Re: Edwards Aquifer, Comal County
NAME OF PROJECT: Heritage Business Park, 1650 and 1672 Independence Drive; New Braunfels, Texas
TYPE OF PLAN: Request for Modification of a Water Pollution Abatement Plan (WPAP); 30 Texas Administrative Code (TAC) Chapter 213 Edwards Aquifer
Edwards Aquifer Protection Program File No. 1814.00, Regulated Entity Reference Number RN102750627 and Edwards Aquifer Protection Program File No. 1605.00, Regulated Entity Reference Number RN102751252

HERITAGE BUSINESS PARK

Water Pollution Abatement Plan Modification

Re: Heritage Business Park
Water Pollution Abatement Plan Modification
TNRCC Project No. 1814.00 and 1605.00

**HERITAGE BUSINESS PARK
ORIGINAL WATERSHED AREAS**

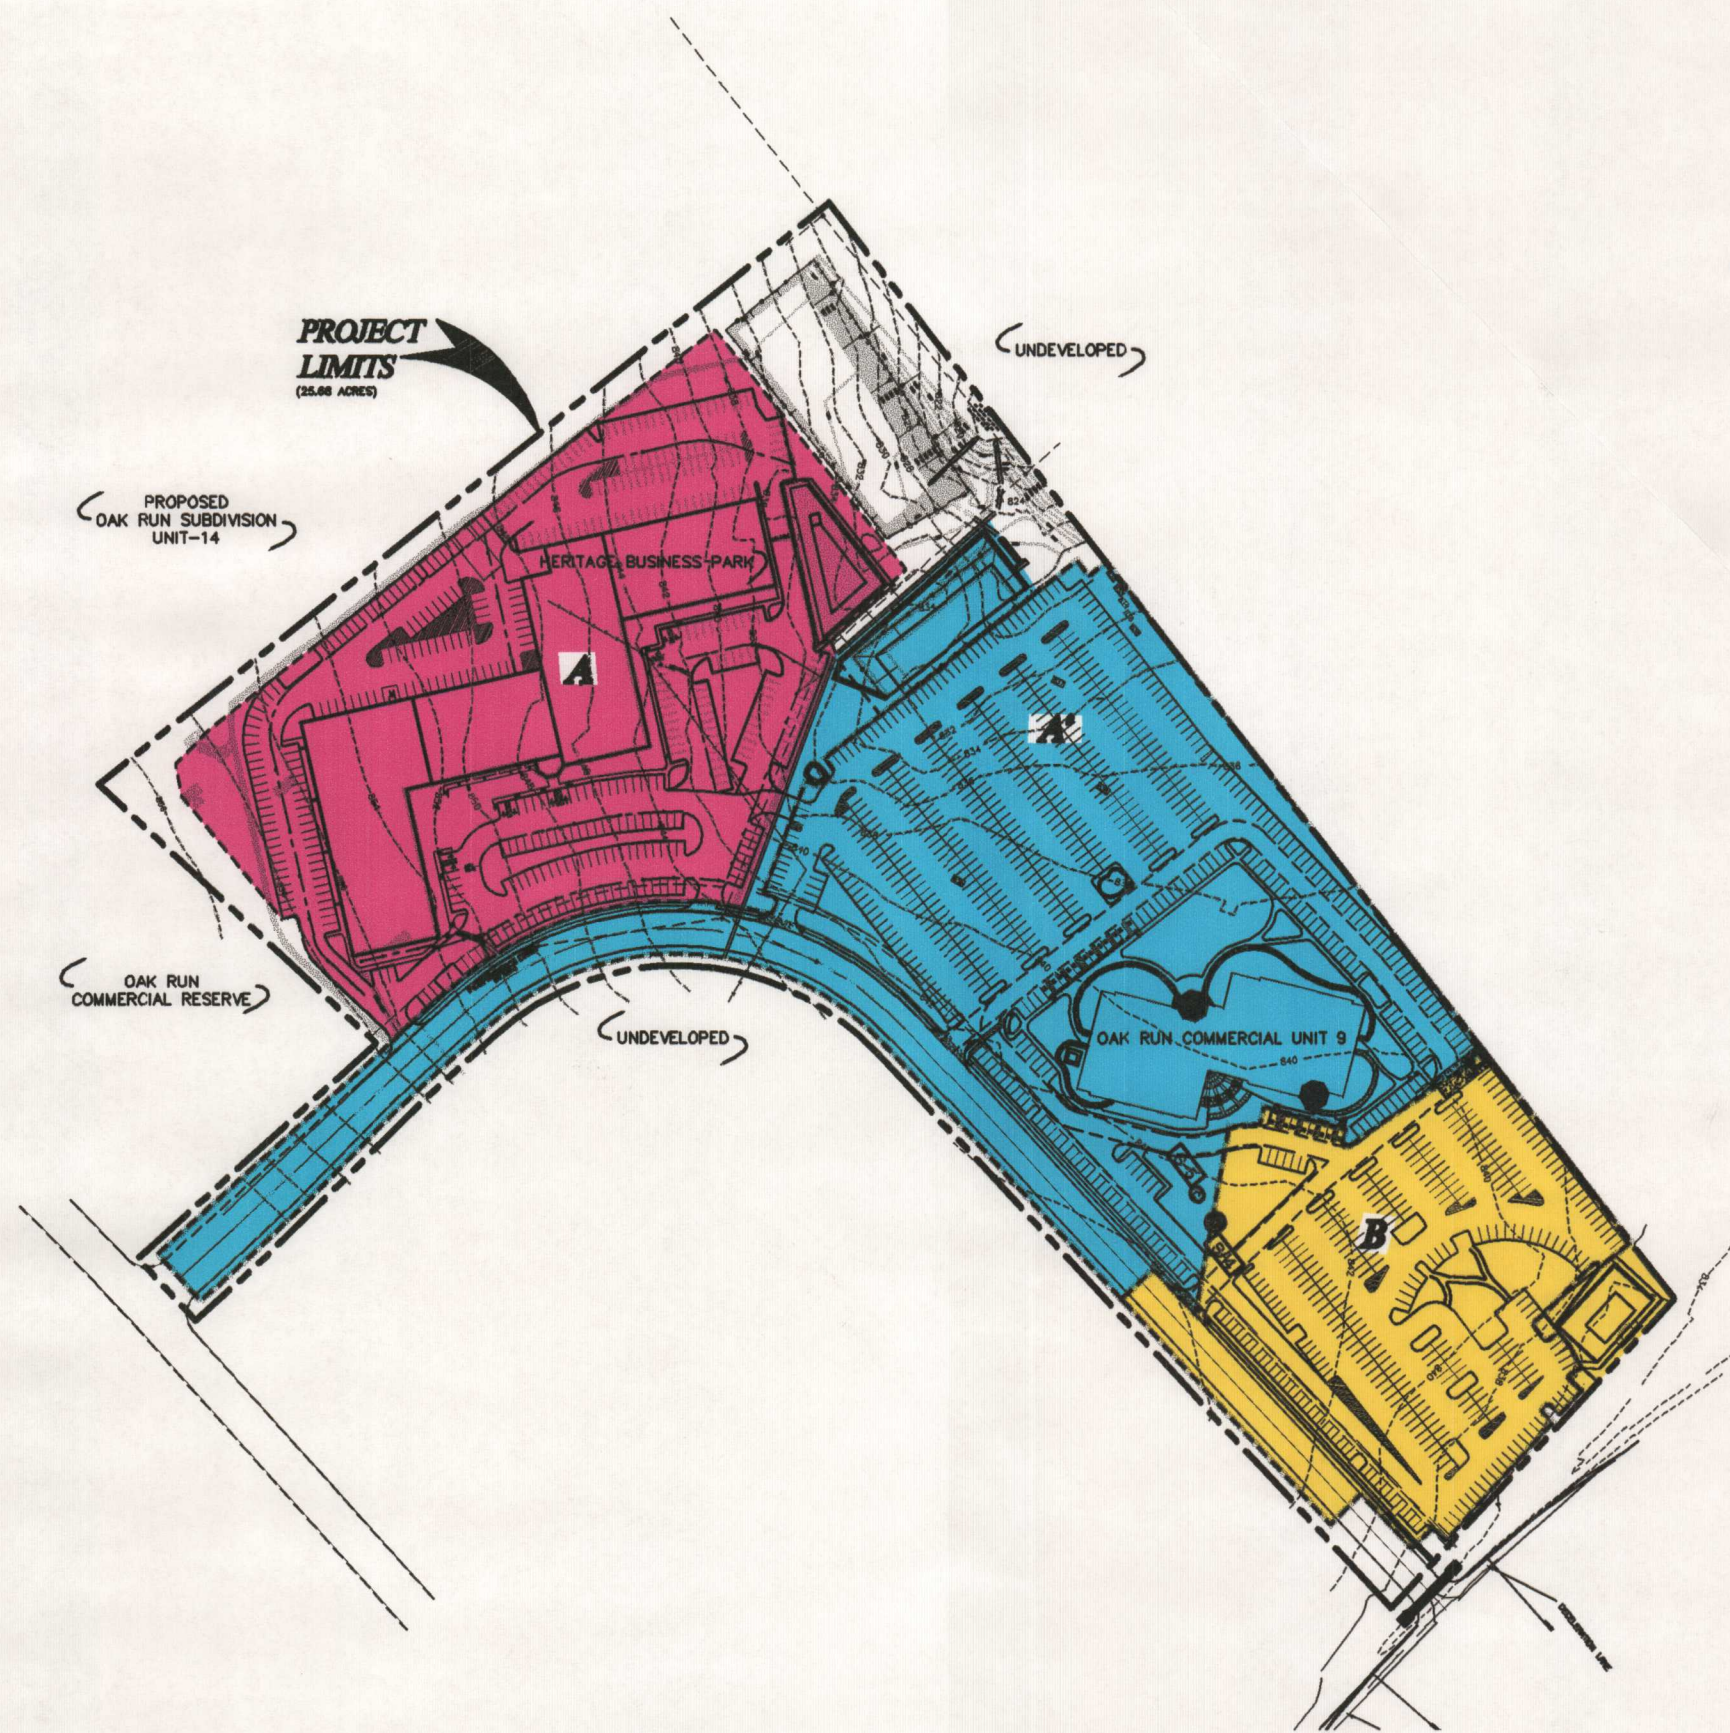
- Runoff from each site is directed to water quality basins within their respective site.
- Both water quality basins overflow to one common detention basin.
- Upgradient runoff is directed around both sites and the detention basin then discharged directly to the creek at the rear of the sites.

The attached exhibits show the original and modified watersheds and drainage patterns. Also attached is a summary of design criteria for both water quality basins as approved under the original WPAPs and as proposed in this WPAP Modification.

HERITAGE BUSINESS PARK
REVISED WATERSHED AREAS
1 OF 1

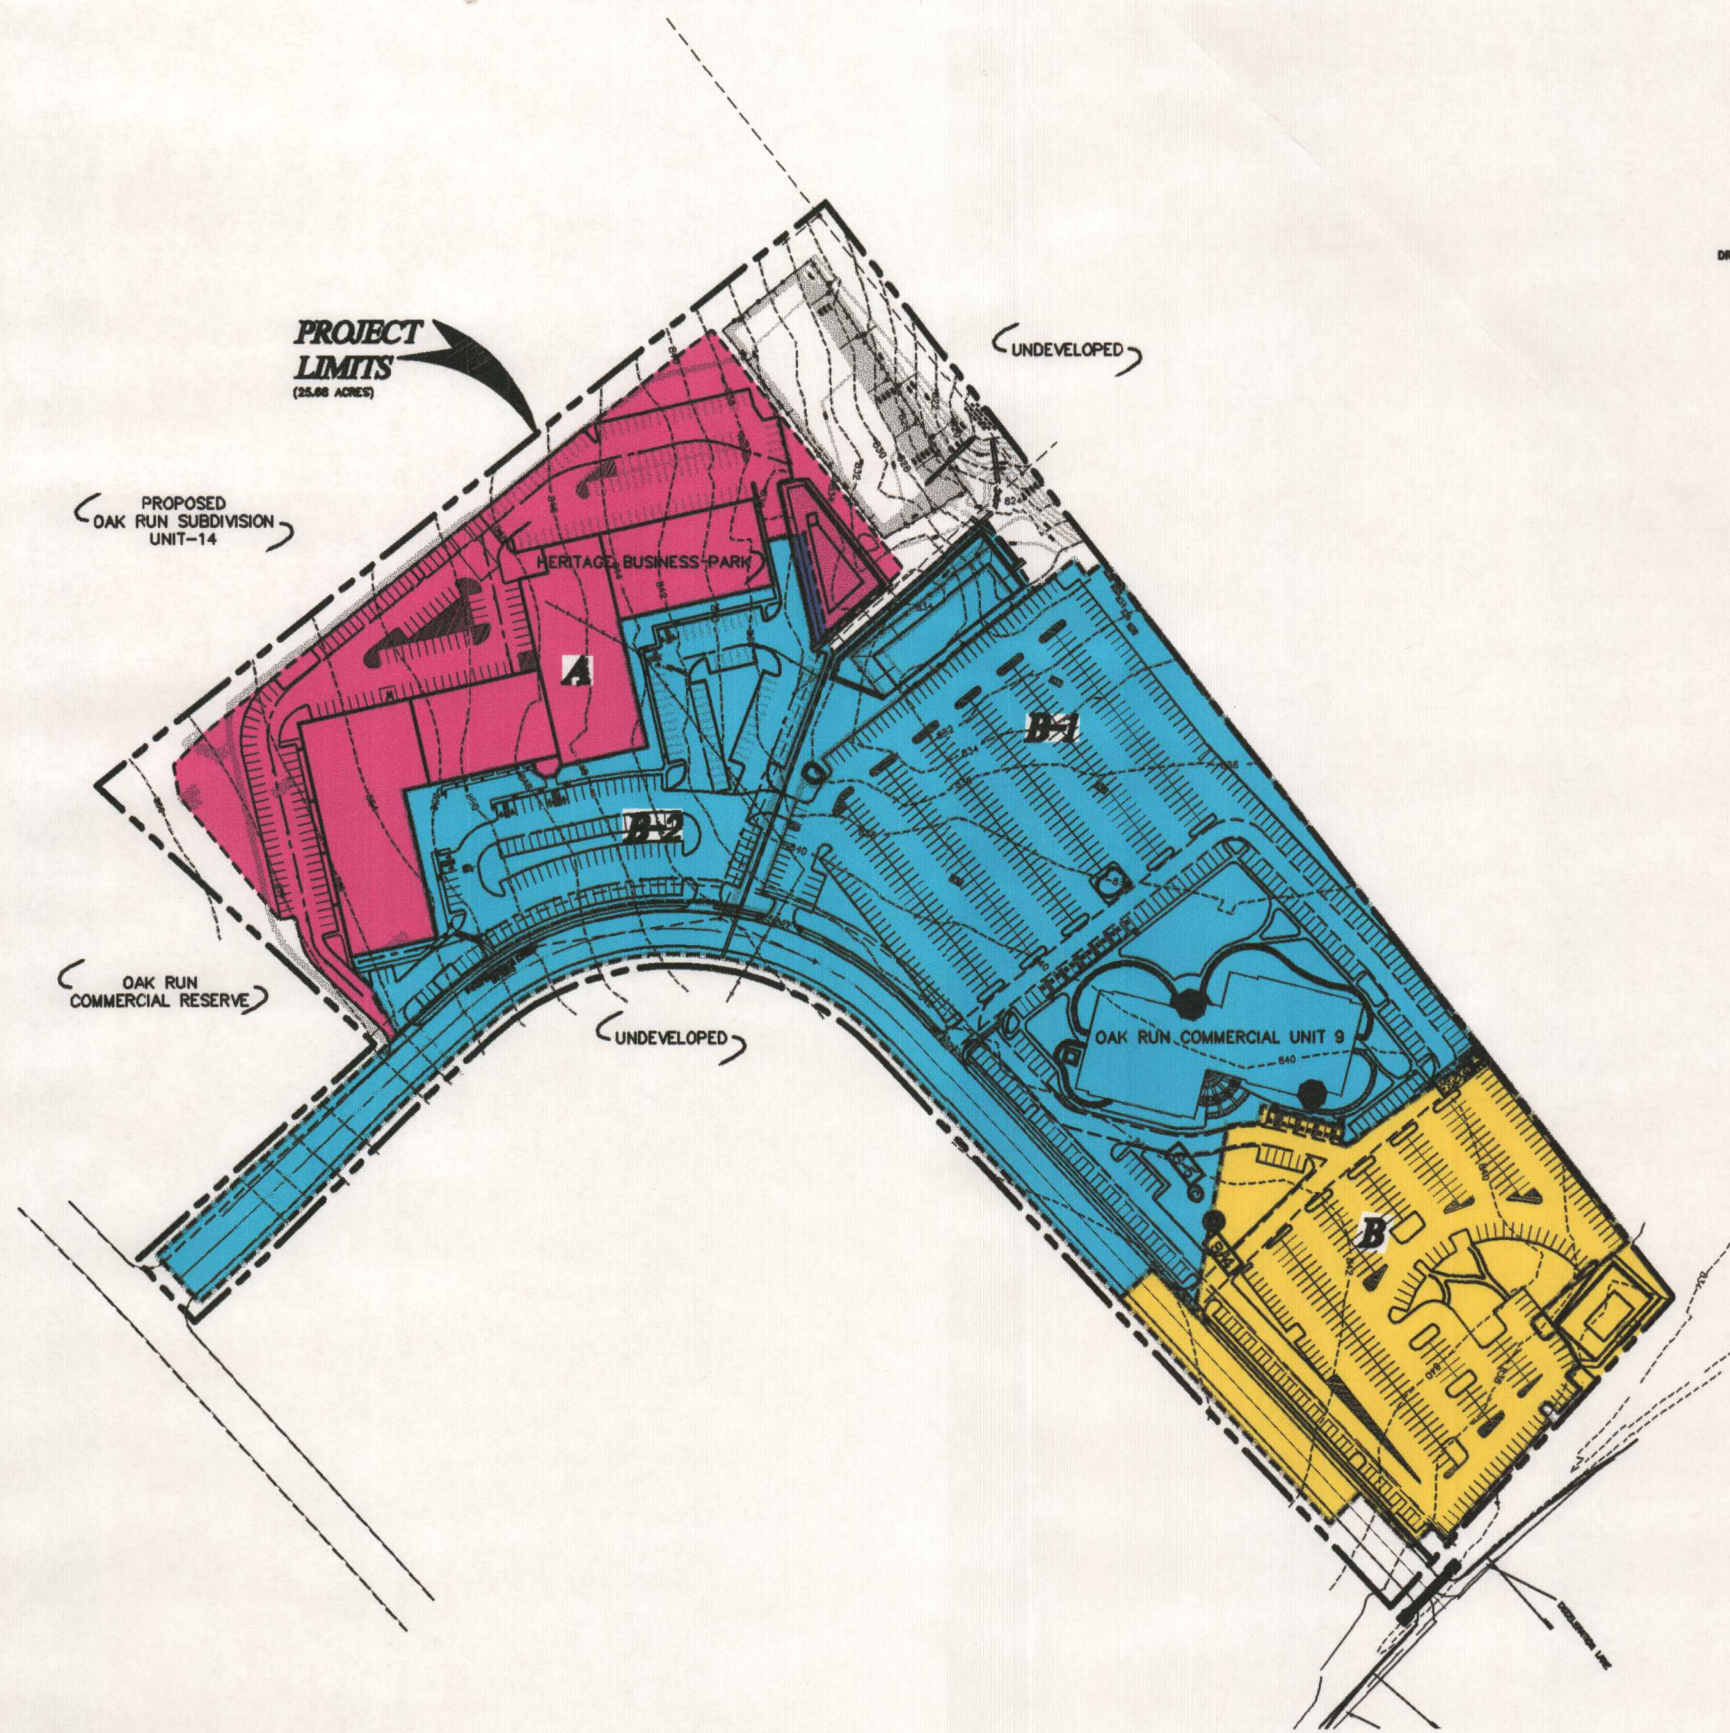
- Runoff from Watershed B-2 (2.68 acres) within the Heritage site is redirected to Basin B-1 within the Oak Run site. This requires the storage volume of Basin B-1 to be increased because the watershed draining to the basin has increased by 2.68 acres. This also results in the storage volume of Basin B to decrease because of the reduction in watershed size.
- Overflow from Basin B-1 is discharged to the creek instead of being sent to the detention basin.

- Upgradient runoff is directed around the Heritage Business Park site and directly into the detention basin. This upgradient runoff is detained in lieu of detaining the on-site runoff.

HERITAGE BUSINESS PARK
WATER POLLUTION ABATEMENT BASIN "B-1"
SHEET 1 OF 2

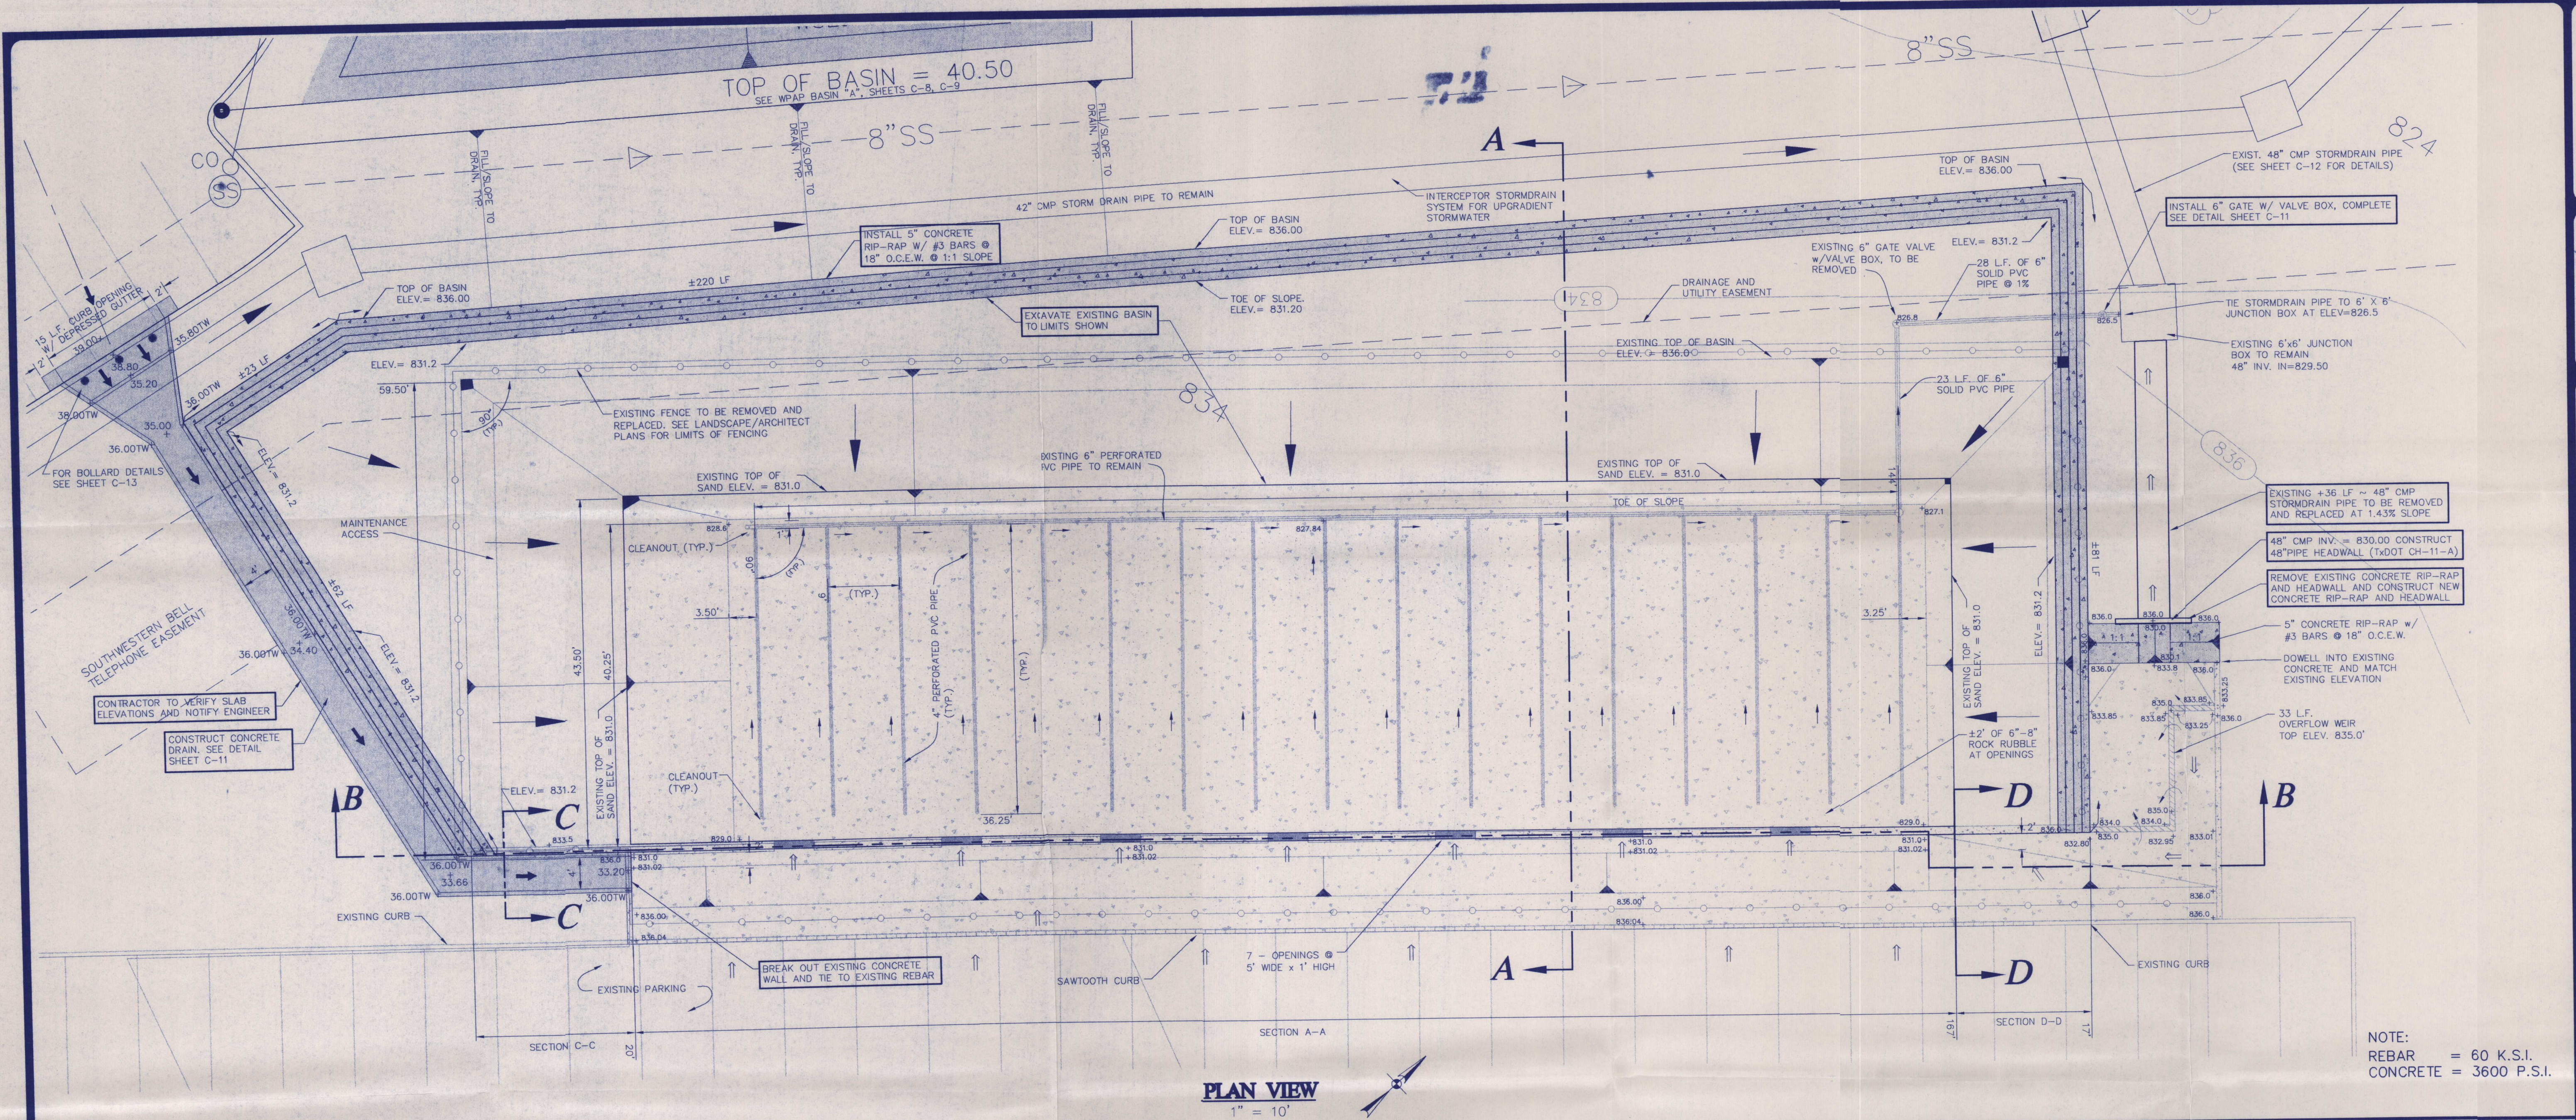
Basin B-1 from 37,253 cubic feet (CF) to 55,823 CF and the required sand surface area from 3,991 square feet (SF) to 5,981 SF. As originally constructed, the sand surface area provided for Basin B-1 was 7,264 SF and therefore no adjustment to the sand will be required under this modification, only the water quality storage volume will be adjusted. The revision will decrease the required volume of Basin A from 34,897 CF to 25,995 CF and the required sand surface area from 2,908 SF to 2,437 SF. Both sedimentation/filtration basins have been designed to remove 80% of the increased Total Suspended Solids (TSS) for the entire watershed area it is intended to treat in accordance with TNRCC's Technical Guidance Manual RG-348 (1999).
